UNITED STATES PATENT AND TRADEMARK OFFICE

APPLICATION NO.	FILING DATE	FIRST NAMED INVENTOR	ATTORNEY DOCKET NO.	CONFIRMATION NO.
10/559,621	12/06/2005	Steven Thomas Slunick	60158-315	2760
26/096 7590 10/29/2008 CARLSON, GASKEY & OLDS, P.C. 400 WEST MAPLE ROAD SUITE 350 BIRMINGHAM, MI 48009				
EXAMINER				
KEE, FANNIE C				
ART UNIT		PAPER NUMBER		
3679				
MAIL DATE		DELIVERY MODE		
10/29/2008		PAPER

Office Action Summary

3DETAILED ACTION

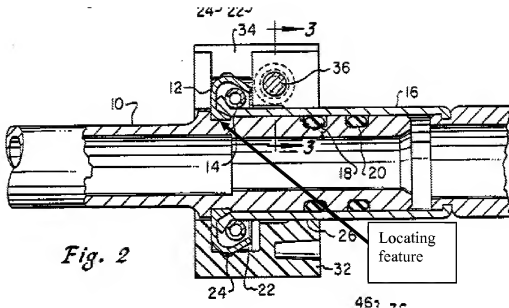
7. Claims 1, 6, 7, 13, 14, and 20-24 are rejected under 35 U.S.C. 103(a) as being unpatentable over Bartholomew U.S. Patent No. 5,826,920.

With regard to claim 1, and as seen in Figure 1, Bartholomew discloses a fluid connection assembly comprising:

a housing (22, 28) including a fluid port;
a tube (24);
a seal (26) located between the tube and the fluid port;
a retainer (90) to secure the fluid port to the tube; and
a locating feature (96) to prevent relative rotation between the fluid port of the housing and the tube.

With regard to claim 6, and as seen in Figure 1, Bartholomew discloses the fluid port (22, 28) being inserted into the tube (24), and the fluid port includes an annular collar (28) and the tube includes a flared end (64) that abuts the annular collar.

With regard to claim 7, and as seen in Figure 1, Bartholomew discloses the retainer (90) being molded over the annular collar of the fluid port and the flared end of the tube.

With regard to claim 14, and as seen in Figure 1, Bartholomew discloses at least one of the fluid port and the metal tube including a locating feature (96), and the material of the retainer being received in the locating feature to prevent relative rotation between the fluid port of the manifold and the tube.

With regard to claim 20, and as seen in Figure 1, Bartholomew discloses said locating feature including a first locating feature and a second locating feature, and said fluid port including said first locating feature (96) and said tube including said second locating feature (78).

With regard to claim 21, and as seen in Figure 1, Bartholomew discloses an annular collar (28) of said fluid port including said first locating feature (96) and a flared end (64) of said tube including said second locating feature (78).

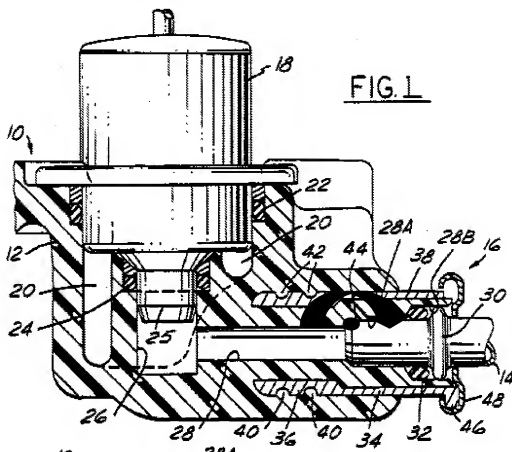
With regard to claim 1, and as shown in Figure 2 below, Smith discloses a fluid connection assembly comprising:

- a housing (10) including a fluid port;
- a tube (16);
- a seal (18) located between the tube and the fluid port;
- a retainer (12) to secure the fluid port to the tube; and
- a locating feature to prevent relative rotation between the fluid port of the housing and the tube.

With regard to claim 8, and as shown in Figure 2 above, Smith discloses the fluid port includes at least one annular recess that receives the seal.

With regard to claim 9, and as shown in Figure 2 above, Smith discloses at least one of the fluid port and the tube including the locating feature, and the material of the retainer being received in the locating feature to prevent relative rotation between the fluid port of the housing and the tube.

preventing rotation between the fluid port of the housing and the metal tube (see locating feature in Figure 2 above).

With regard to claim 16, and as shown in Figure 2 above, Smith discloses the step of inserting the fluid port into the metal tube.

With regard to claim 17, and as shown in Figure 2 above, Smith discloses the step of preventing over insertion of the metal tube during the step of inserting the fluid port into the metal tube (the connection at 28 and 64).

With regard to claim 18, and as shown in Figure 2 above, Smith discloses the step of retaining including molding a retainer (90) over a joint of the metal tube and the fluid housing.

FIGURE 1

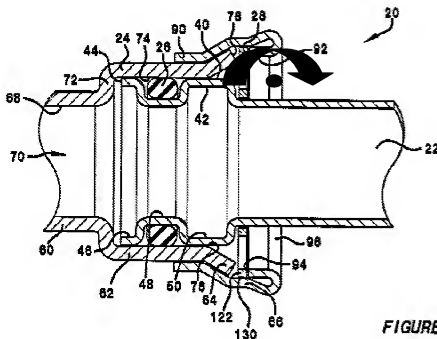
a. Applicant argues that Imoehl does not disclose a locating feature which is equivalent to Applicant's locating feature because it does not prevent relative rotation between the fuel rail 12 and the tube 14.

Applicant has not defined what type of relative rotation is being prevented. As shown below, the locating feature in Imoehl does prevent relative rotation between the fuel rail and the tube.

b. Applicant argues that Bartholomew does not disclose a locating feature which is equivalent to Applicant's locating feature because it does not prevent relative rotation between the fluid port of the housing and the tube.

Applicant has not defined what type of relative rotation is being prevented. As shown below, the locating feature in Bartholomew does prevent relative rotation between the fluid port of the housing and the tube.

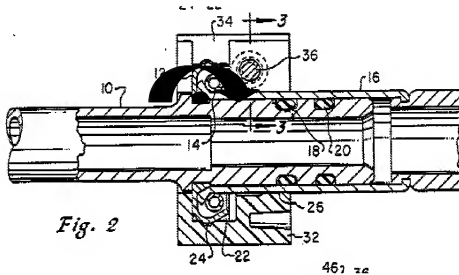
f. Applicant argues that Smith does not disclose a locating feature to prevent relative rotation between the fluid port of the housing and the tube.

Applicant has not defined what type of relative rotation is being prevented. As shown below, the locating feature in Smith does prevent relative rotation between the fluid port of the housing and the tube.
